ATTACHMENT 5

Letter from M. E. Warner (NMC)

License Amendment Request 187

Revised Pages for Updated Safety Analysis Report
(USAR)

Figure 14.1.8-13

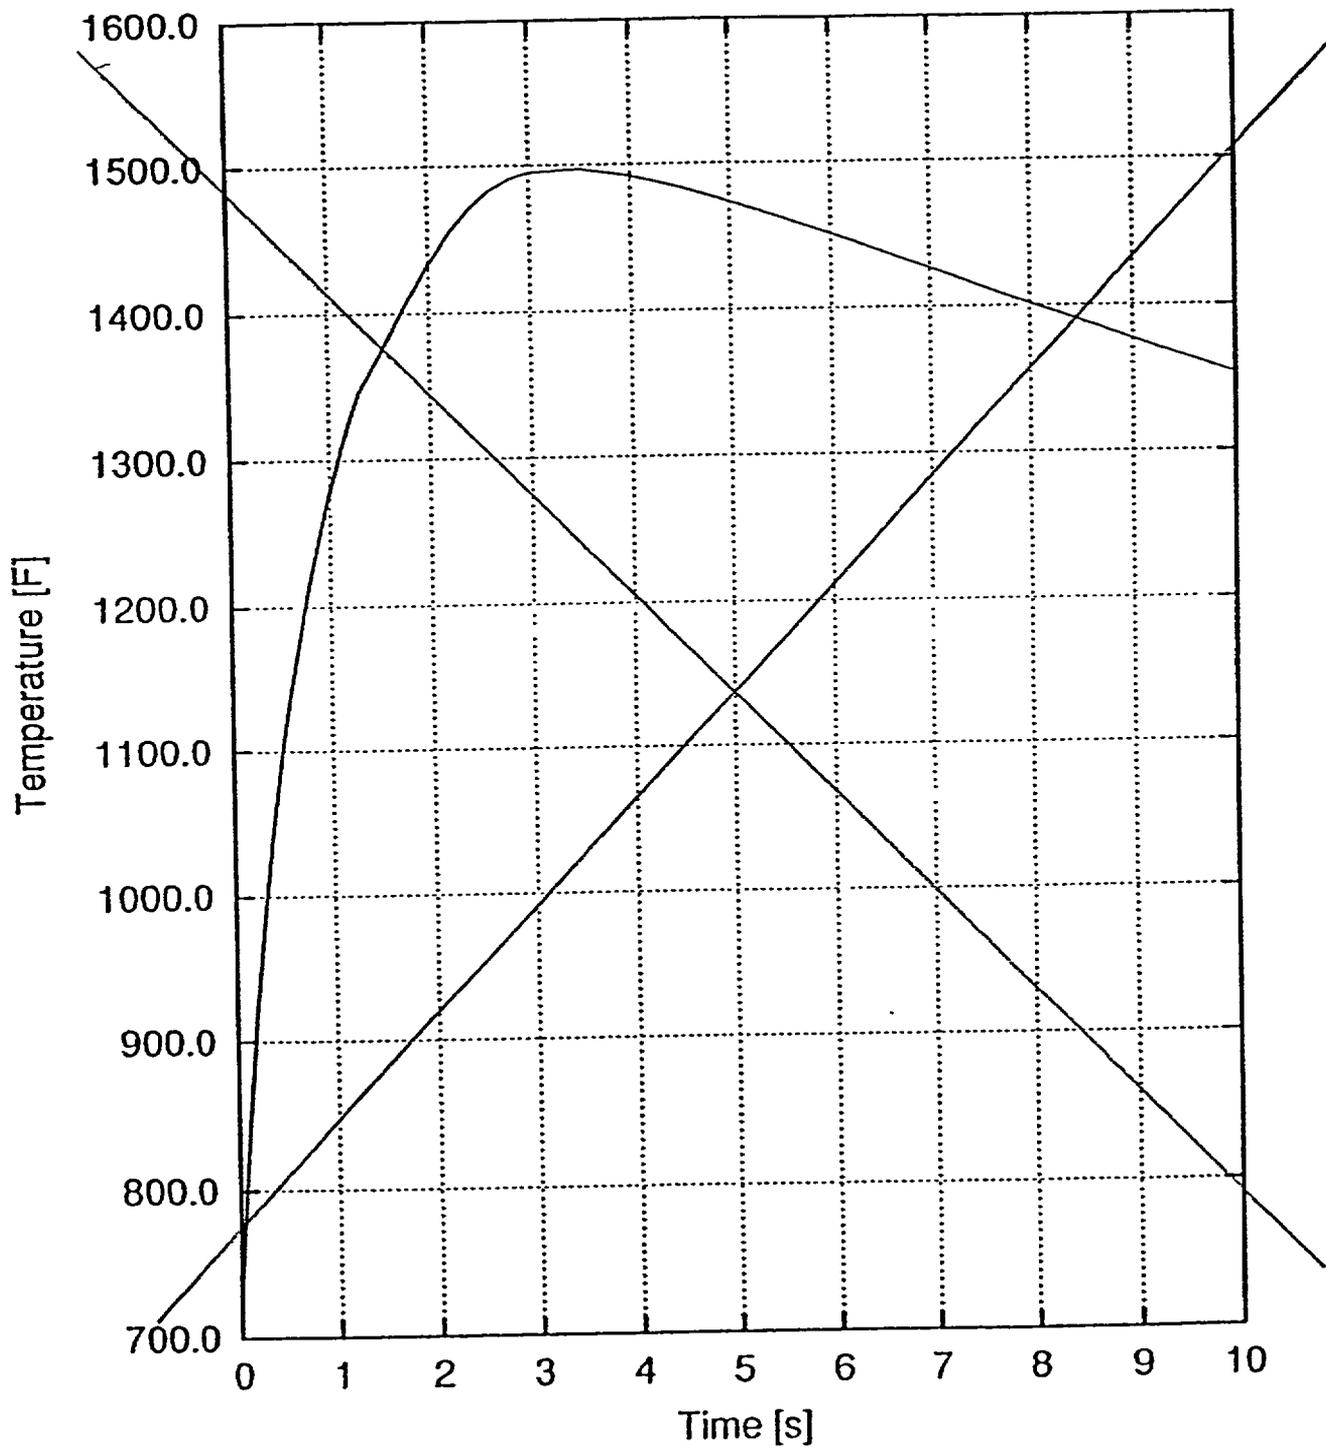
REPLACE WITH NEW FIGURE 14.1.8-13
